Addendum No. 3

Diablo Road Trail and Drainage Improvement Project Project No. C-055

SOLDIER PILE WALL #1 PROFILE
SCALE: 1"=10' (HORIZONTAL); 1"=5' (VERTICAL)

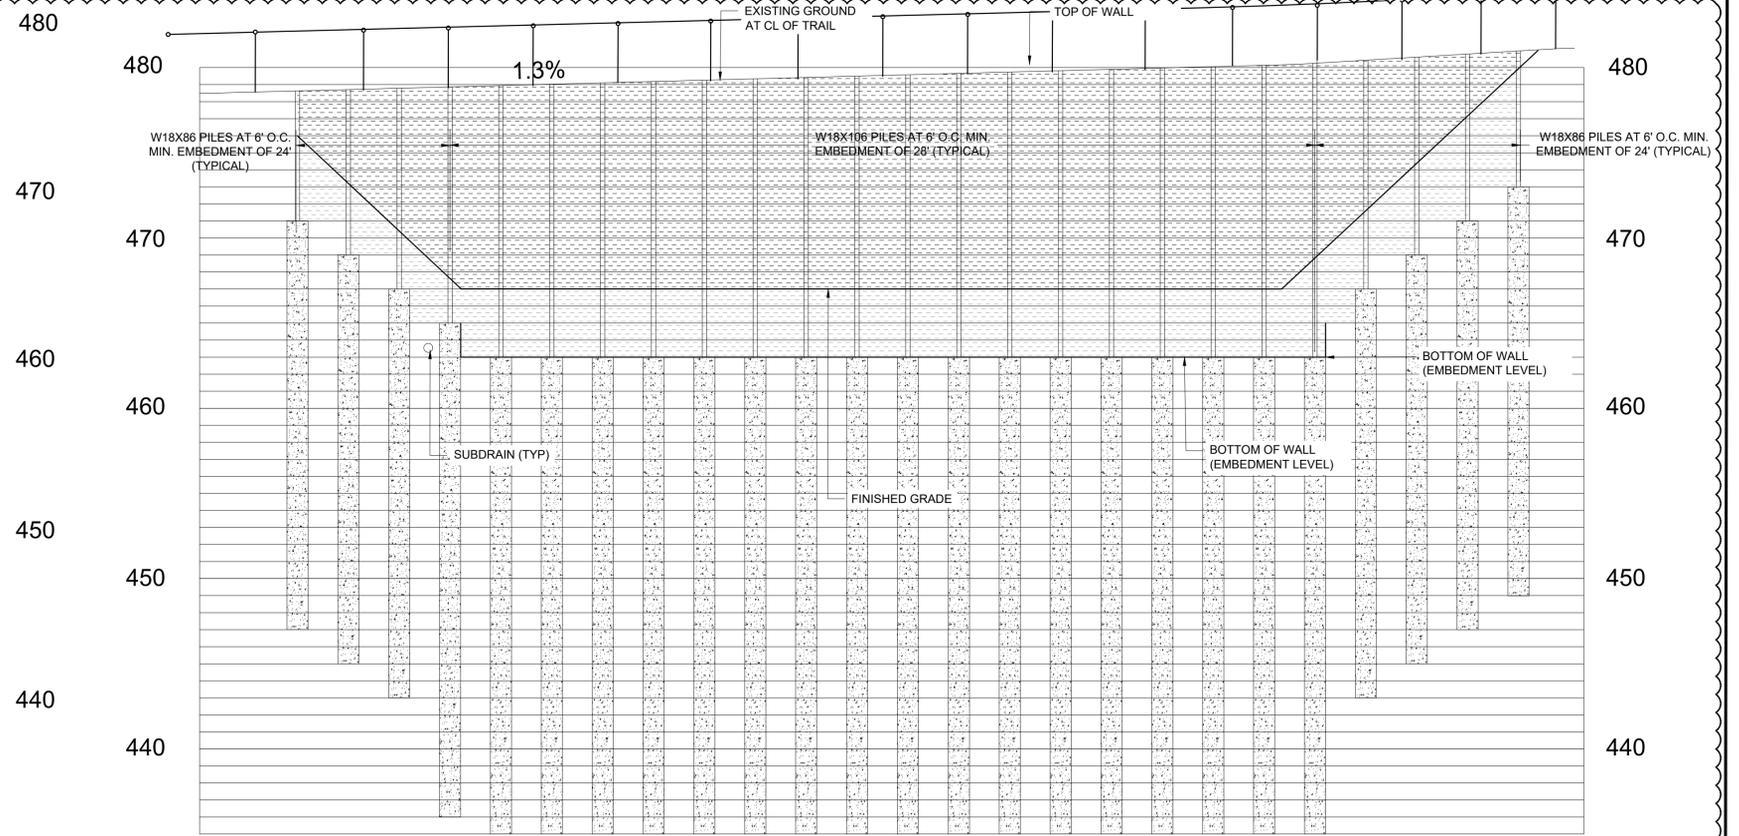
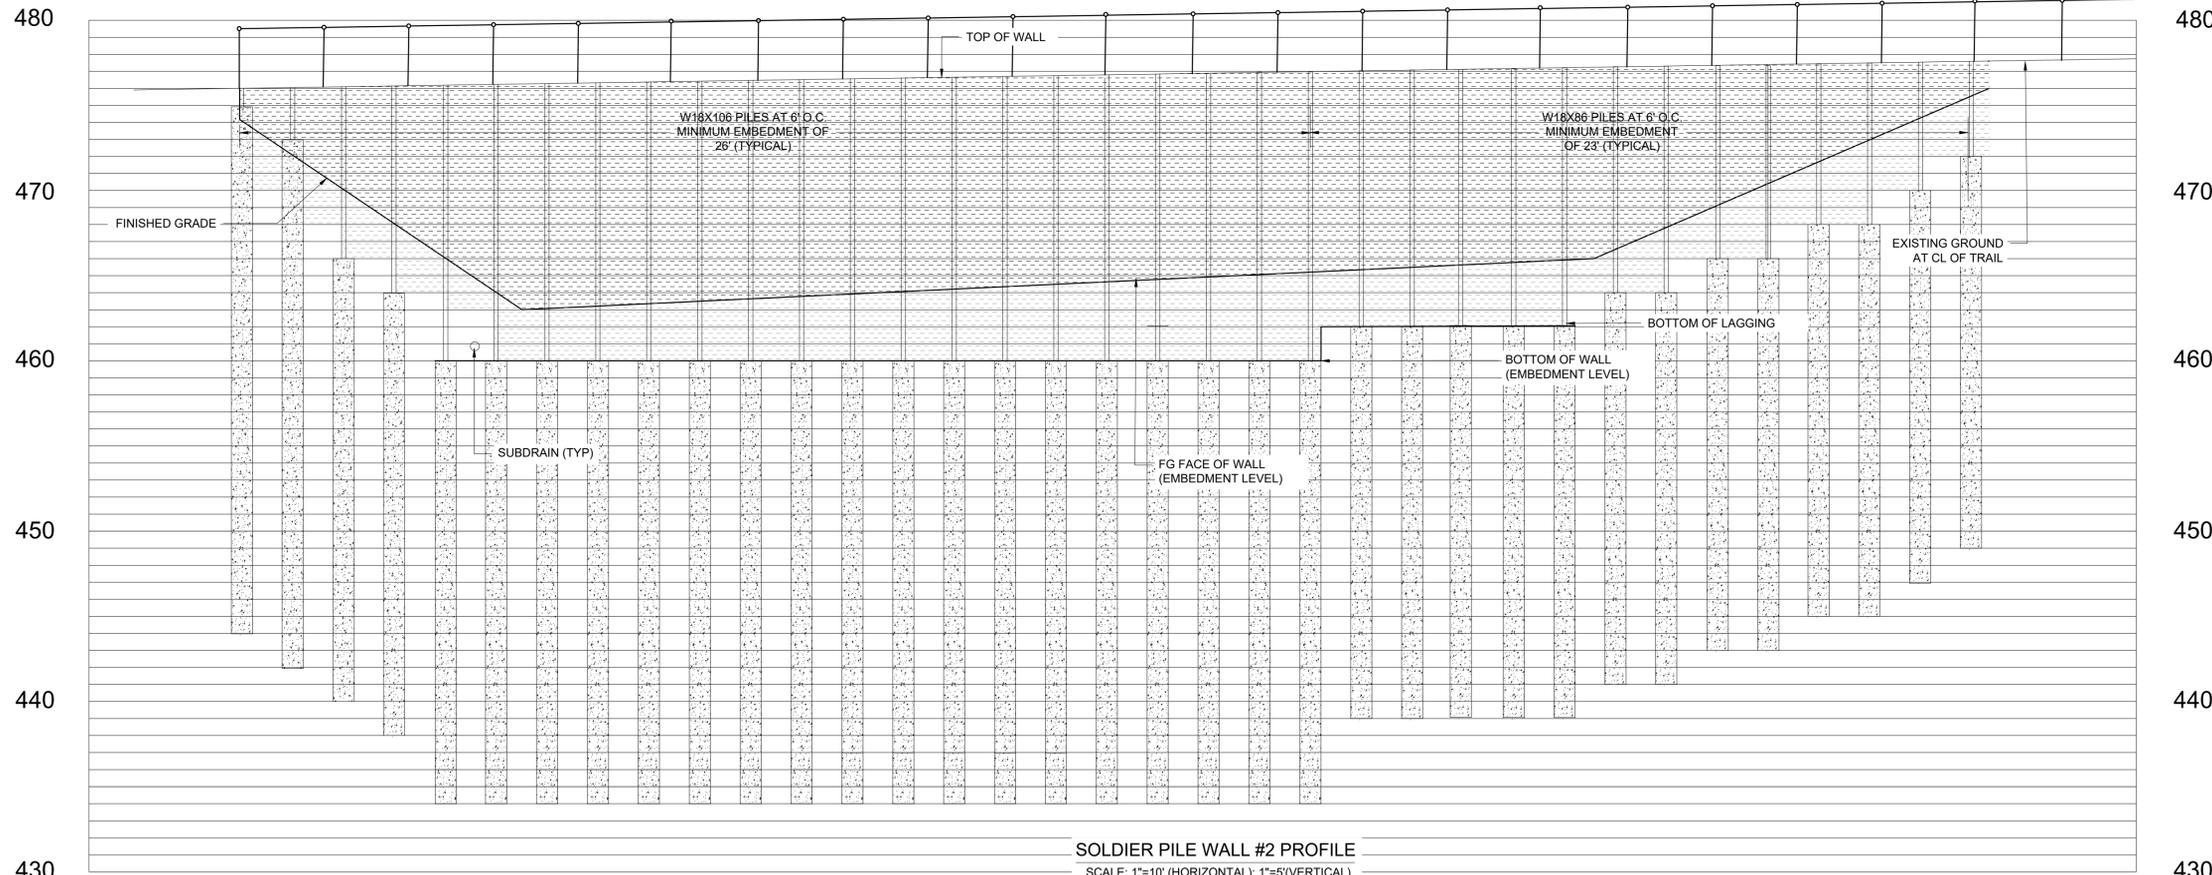
69- Soldier Pile Wall #2 (Plan Sheet 17) calls for W18x186 steel beams. These beams do not exist. Please confirm which steel beams are to be used in lieu of the W18x186 beams.

94-Profiles Shown on Sheet 17 show the Profiles for Soldier Pile Walls #1 - #3. All of them show the top of wall Precast Concrete Lagging matching the contour of the new path. Cutting the concrete lagging to match would be an arduous task. Could the City please consider a different design option for the top of Soldier Pile wall(s)?

4 TYPICAL ROCK RIP-RAP APRON DETAIL
NO SCALE

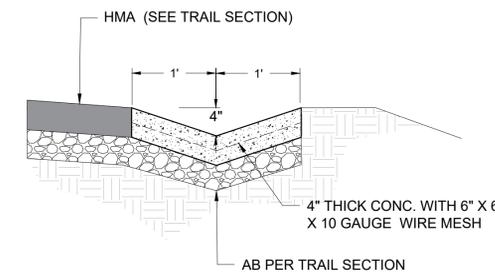
57- Please confirm you want 200 lb rock rip-rap in the 3.0' X 3.0' outfall aprons. See detail 4 on plan sheet 18.

98- Please confirm you want 200 lb rock rip-rap in the 3.0' X 3.0' outfall aprons. See detail 4 on plan sheet 18.
